# Work Order ID 85828

Item Name: Crosstube Turning Detail

DRAWING NO. D212-664-141	TITLE XTUBE ASSY (205/212/412 HI FWD)	REV. D	DART AEROSPACE LTD ENGINEERING ORDER		D.E.O. NO. D212-664-141-D-1	SHEET NO. SHEET 1 OF 2	SCALE NTS
DRAWN	CHECKED	MFG. APPR.	APPROVED	DE APPR.			
DATE 11.04.07	DATE 11.07.11	DATE 11.04.12	DATE 11/04/12	DATE 11.04.12

ADD AN INSPECTION WINDOW TO UNDERSIDE OF CROSSTUBE.

**D212-664-141/-141B  
ASSEMBLY DETAIL**

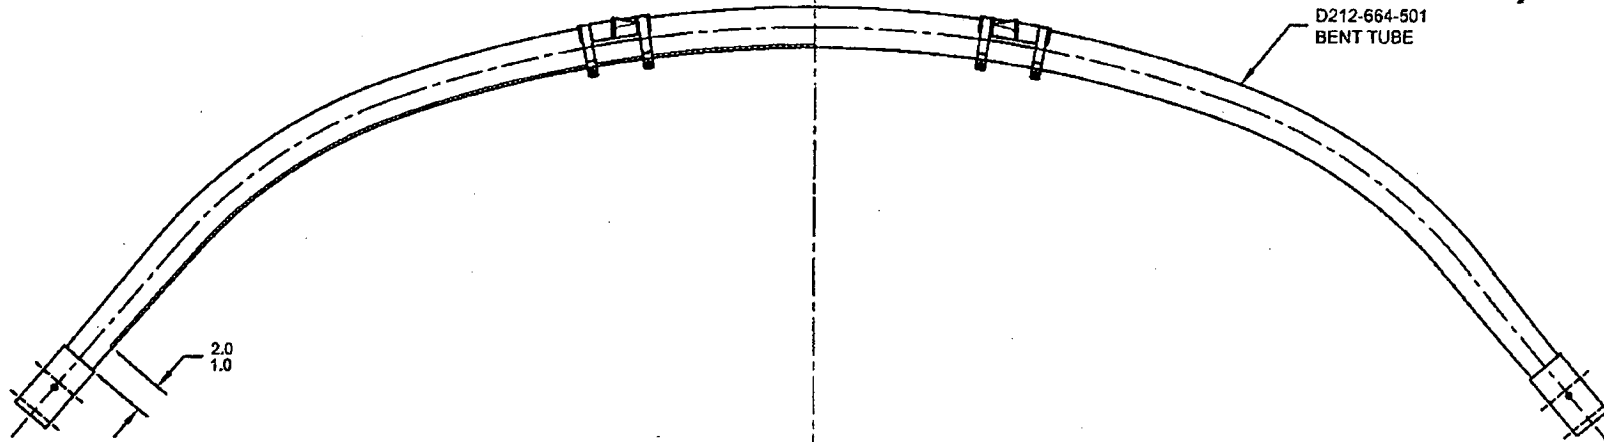
MASK AREA PRIOR TO PAINTING,  
REMOVE MASKING AFTER PAINT  
AND APPLY CLEAR COAT

- 2) FINISH: CHEMICAL CONVERSION COAT PER DART QSI 005 4.1  
PRIME INSIDE AND OUTSIDE PER DART QSI 005 4.2  
MASK UNDERSIDE OF CROSSTUBE AS SHOWN (HATCHED AREA) AND  
PAINT OUTSIDE PER DART QSI 005 4.2  
REMOVE MASKING AND APPLY CLEAR COAT
